Groundwater Transfer Review Summary Form

Transfer/PA # T- 14729

Ground Water Review Form:

Application: T-14729

Hydrograph showing authorized POA CLAC 19441/57291 and CLAC 59817. Dashed lines show the reference levels established for both wells; note that for CLAC 19441/57291 only the lower reference level (254.25 ft BLS) is applicable.

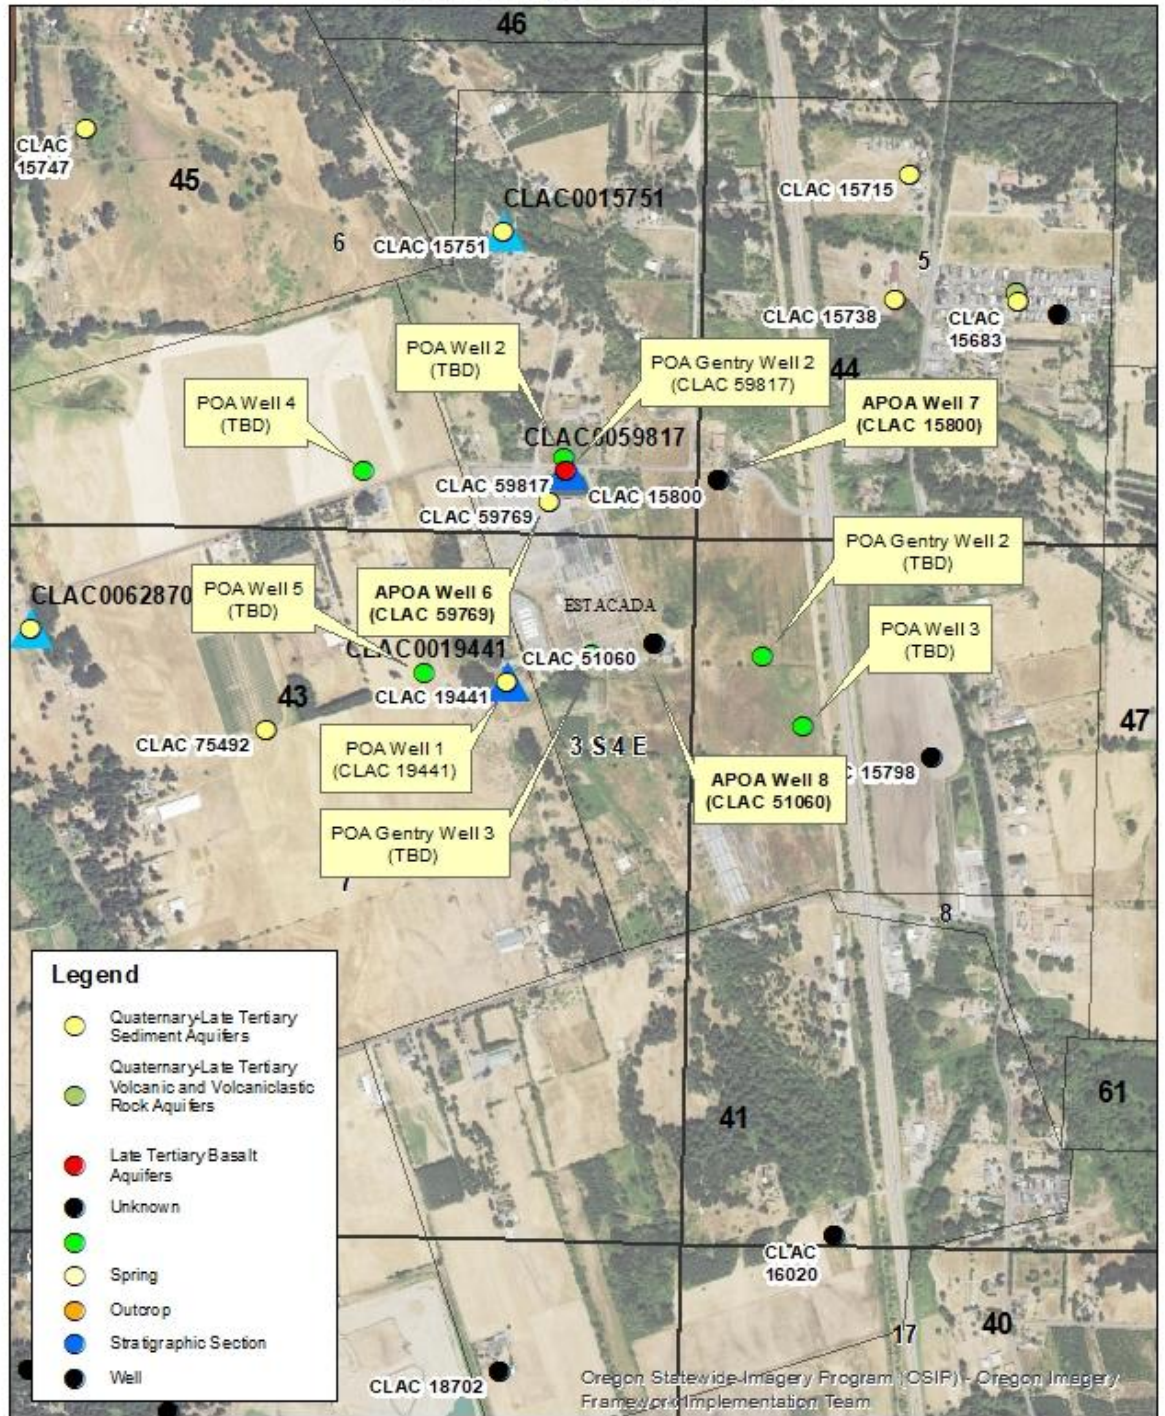
A permit decline condition (total water level decline > 15 feet) has been exceeded for CLAC 59817; this exceedance has existed beginning with the first measurement submitted to OWRD in 2008, and has persisted since that time (see attached hydrograph).

However, the existing wells proposed under this permit amendment as APOA are not completed in the same source as CLAC 59817; instead, those wells share a source with CLAC 19441/57291, which has not exceeded any permit decline conditions.
